PCN – Product Change Notification

Document No	PCN-A-080603	Revision	1.0

ECN Topic: New 21.3 inches ELO 5w touch is integrated into Winmate's Open Frame LCD

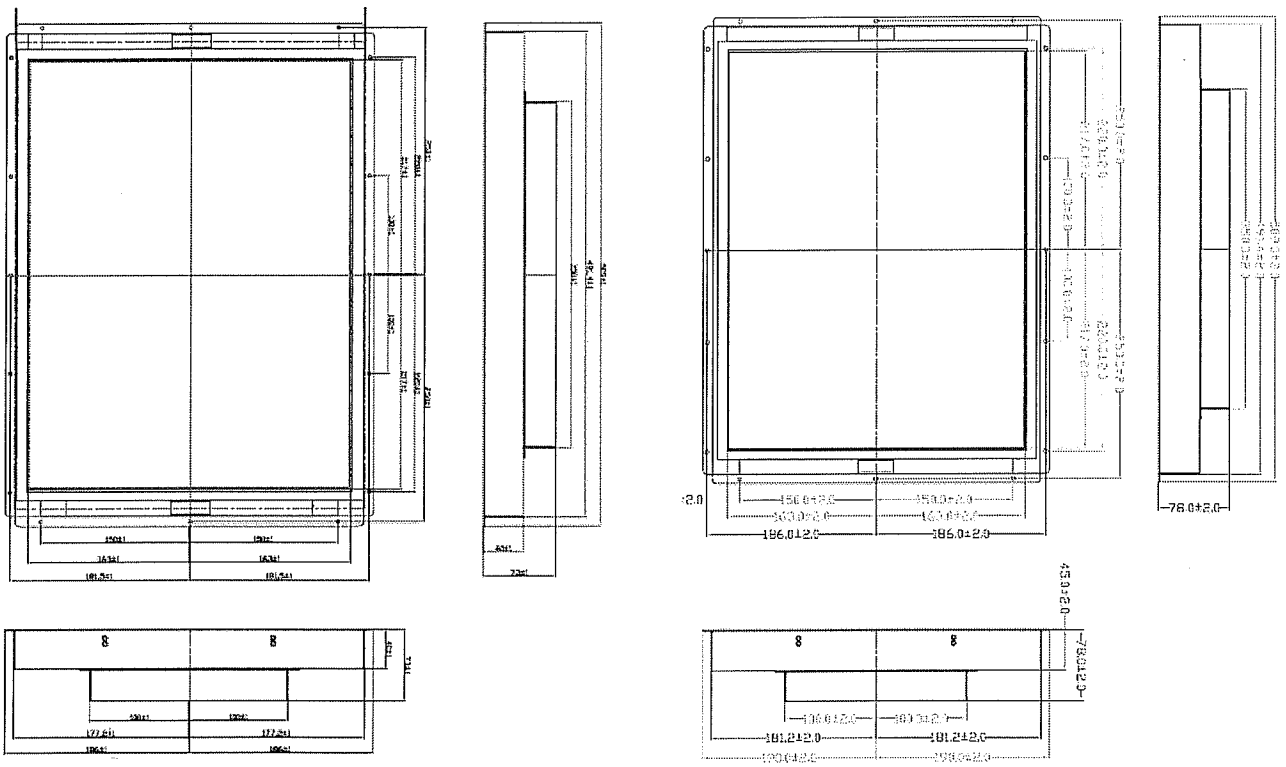
We will use a new 21.3 ELO 5W resistive touch into Open Frame LCD. The dimension of open frame will change to 509*380*78mm from 509*372*73mm

Will be effective from 30th Jun 2008.
